I-5 / 4th ST and 88th ST NE
Corridor Improvements

Tulalip Tribes Project No. 2026-014

ADDENDUM NO. 3 – July 31, 2026

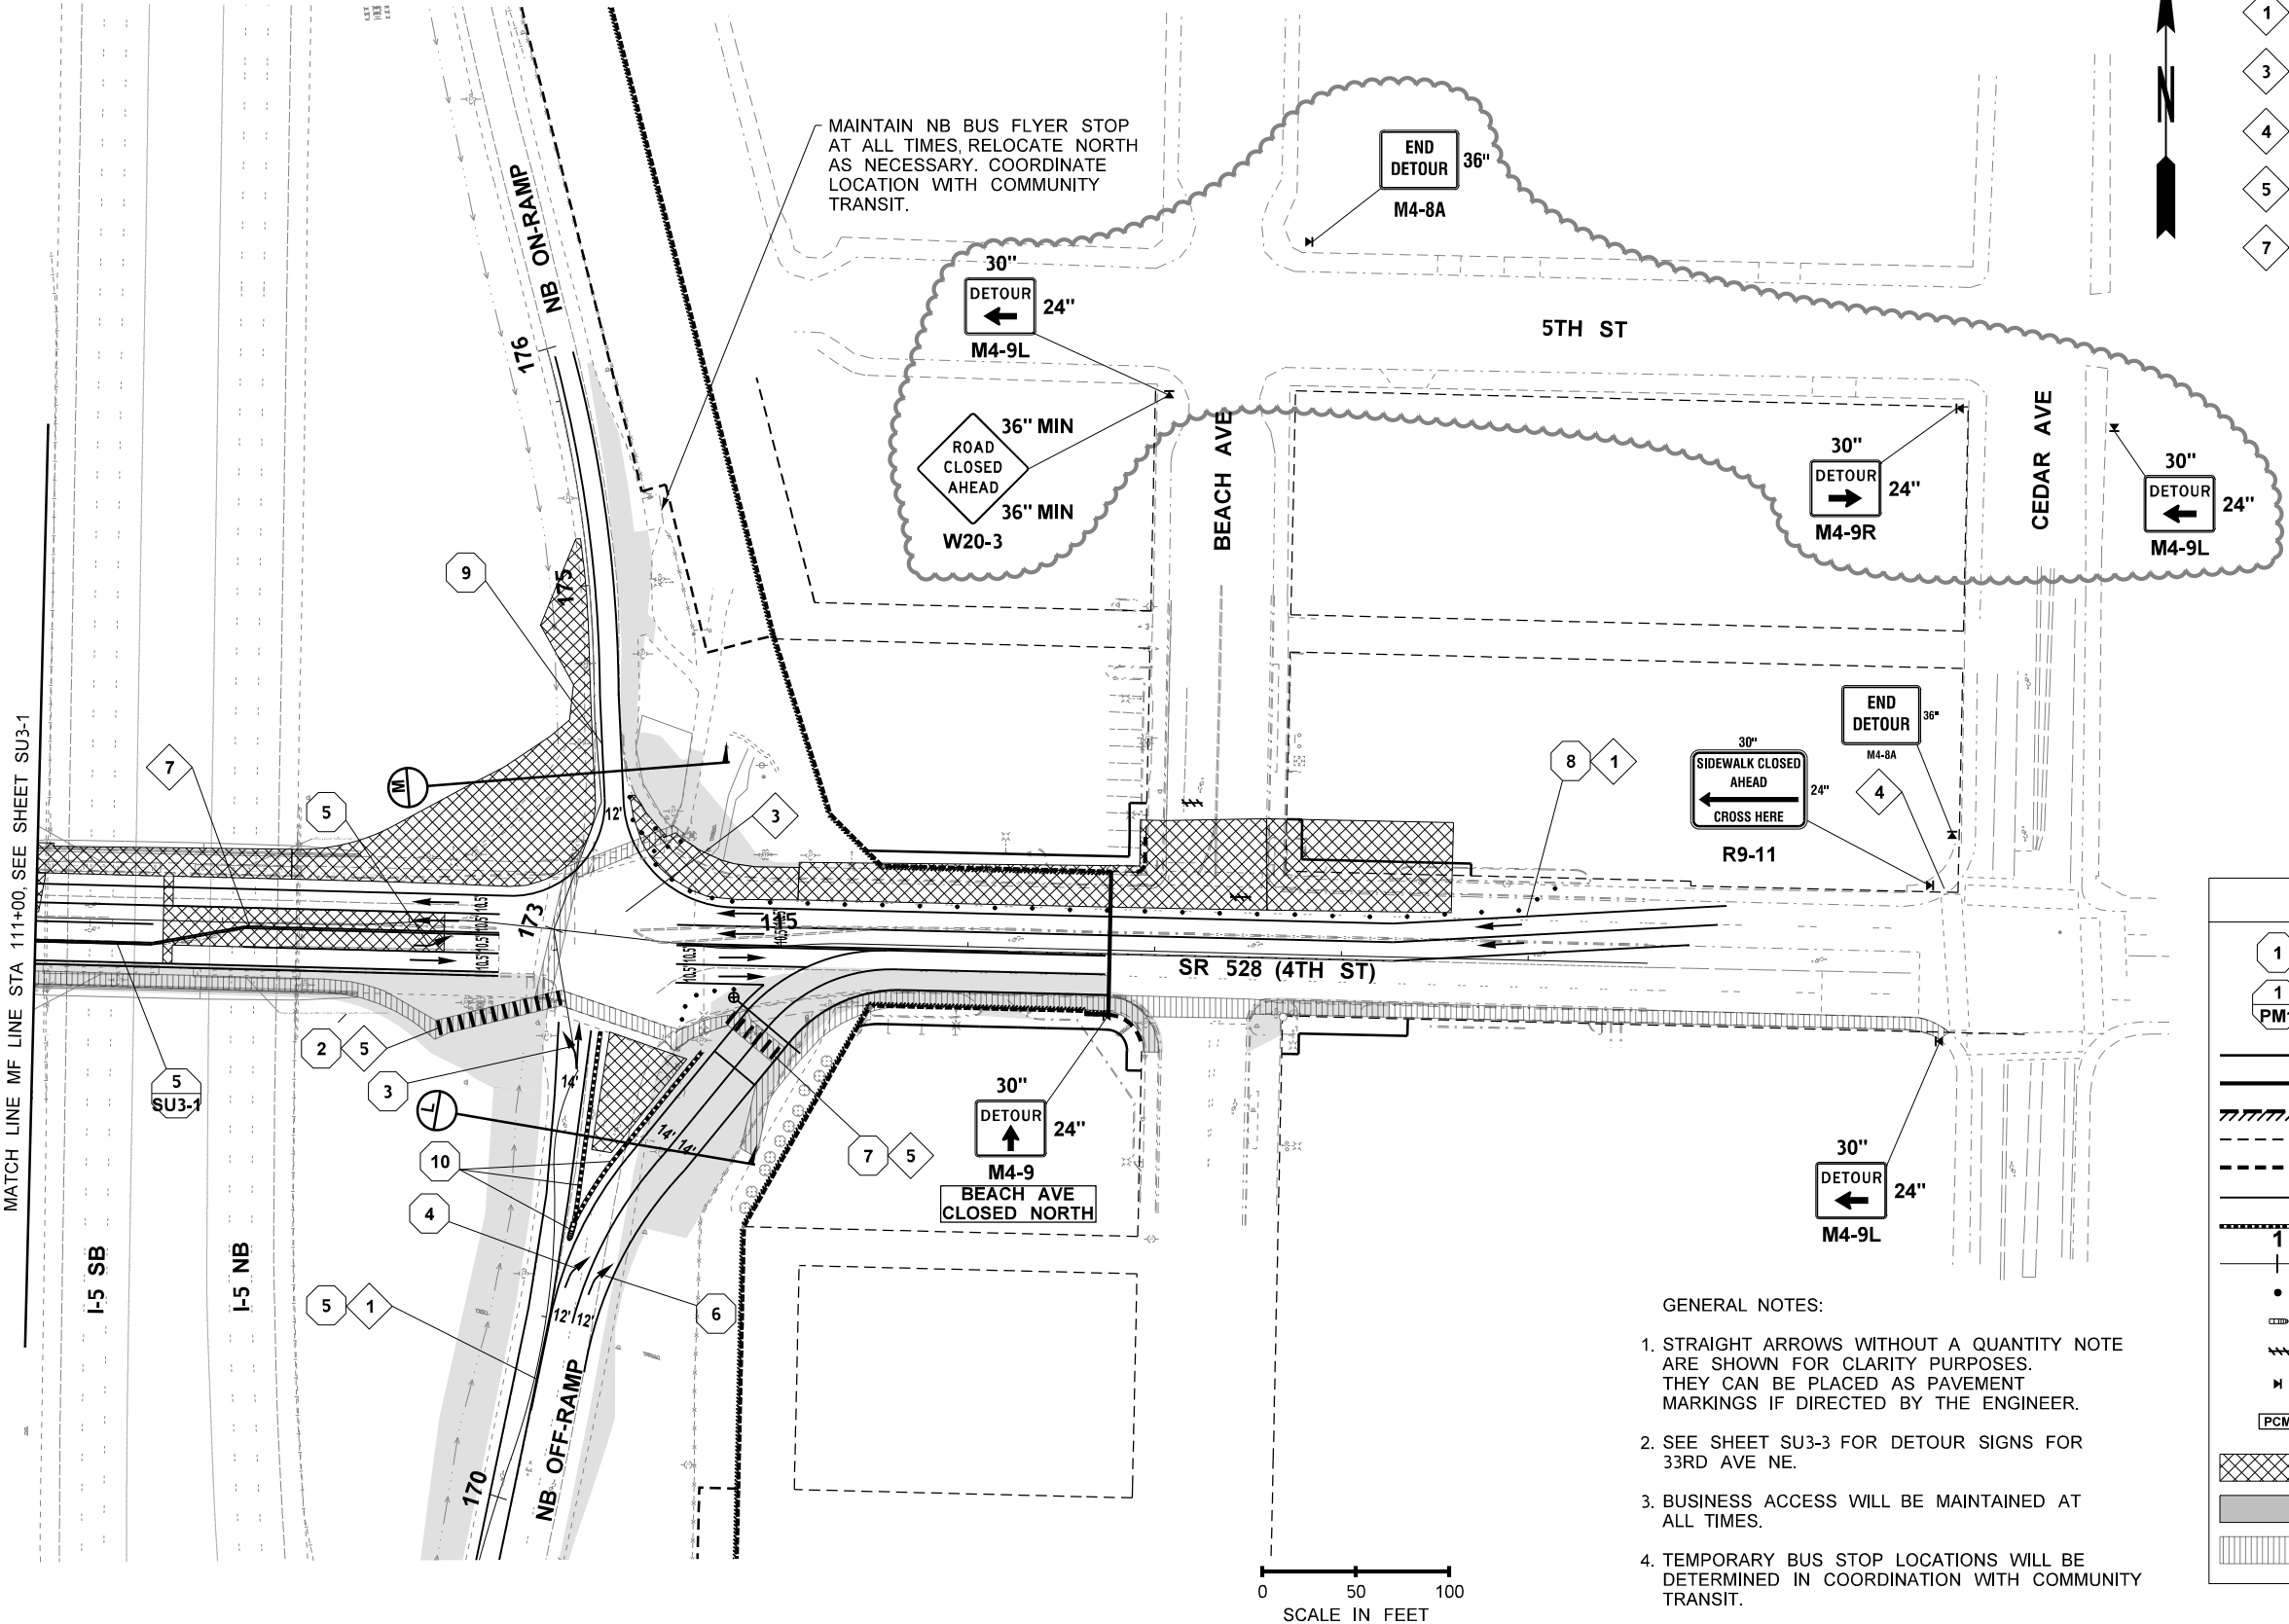
1. Volume 3 sheets SU3-2 and SU4-2 are revised and attached.
2. Volume 3 sheet PM6 – the crosswalk markings on Beach Avenue shall be per City EDDS Standard Plan 3-406-001. The city standard plan is attached to this addendum.

STANDARD PLAN 3-805-001

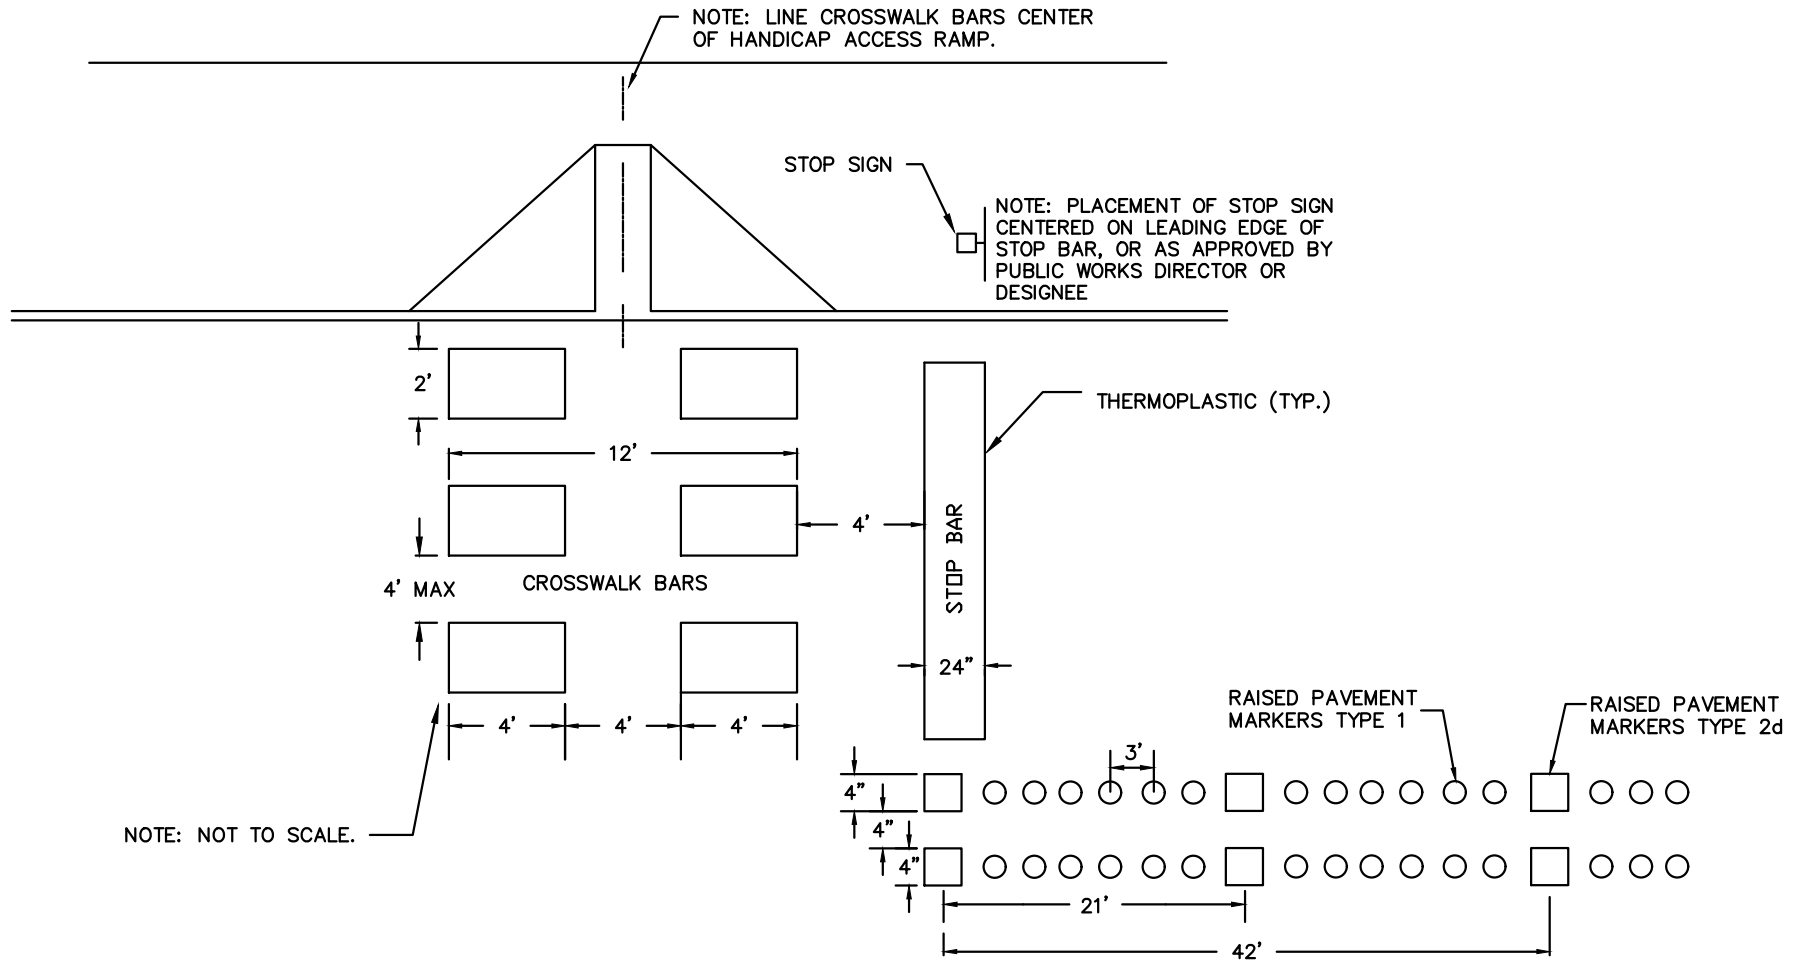
3. Volume 3 all sign specifications sheets, add construction note "All signs to be located within City ROW shall be per City EDDS Standard Plan 3-805-001." The city standard plan is attached to this addendum.

4. Volume 4 all sign specifications sheets, add construction note "All signs to be located within City ROW shall be per City EDDS Standard Plan 3-805-001." The city standard plan is attached to this addendum.
